WEST SUSSEX COUNTY COUNCIL CONSULTATION

TO:	Arun District Council FAO: Andrew Wood
FROM:	Highways, WSCC: Tim Townsend
DATE:	11 th February 2019
LOCATION:	Former Windroos Nursery, Worthing Road, Littlehampton, BN17 6LY
SUBJECT:	LU/25/19/DOC Approval of details reserved by condition imposed on planning reference LU/229/10 relating to Condition 11 - Vehicle Swept Path, Adoption and CMS.
DATE OF SITE VISIT:	
RECOMMENDATION:	☒ Advice ☐ Objection ☒ Modification ☐ No Objection ☒ More Information ☐ Refusal
S106 CONTRIBUTION TOTAL:	£(N/A for purposes of this application)

This is the County Highways Authority (CHA) response to the above planning application for approval of details reserved by condition imposed on planning reference LU/229/10 relating to Condition 11 - Vehicle Swept Path, Adoption and Construction Management Statement (CMS).

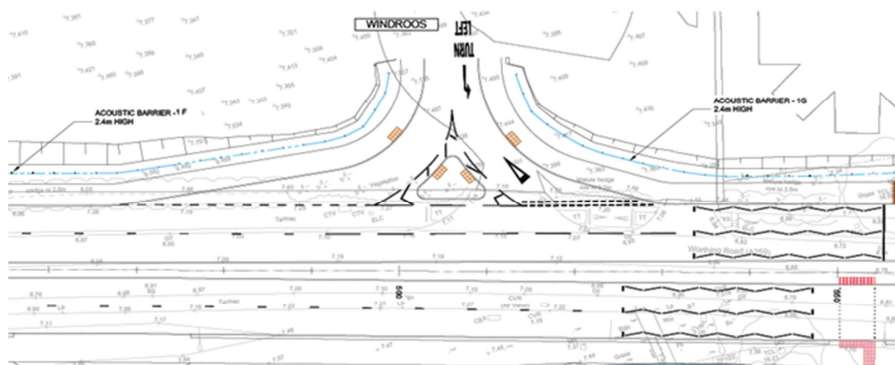
Vehicle swept-path (VSP) – While VSP diagrams have been submitted showing the tracking of both refuse and fire appliance vehicles – both within the layout and through a junction arrangement proposed when the application was originally submitted - the VSP appears on a different version of the layout from that shown on the "S38 General Arrangement" (Drawing No. 063.5001.105 Rev. 'A'). As such, the applicant should confirm the final layout and confirm that the tracking is on the correct drawing. The tracking should also be shown on a drawing showing the proposed alterations to the A259, as proposed by WSCC. Copies of the latter can be obtained on request from the CHA.
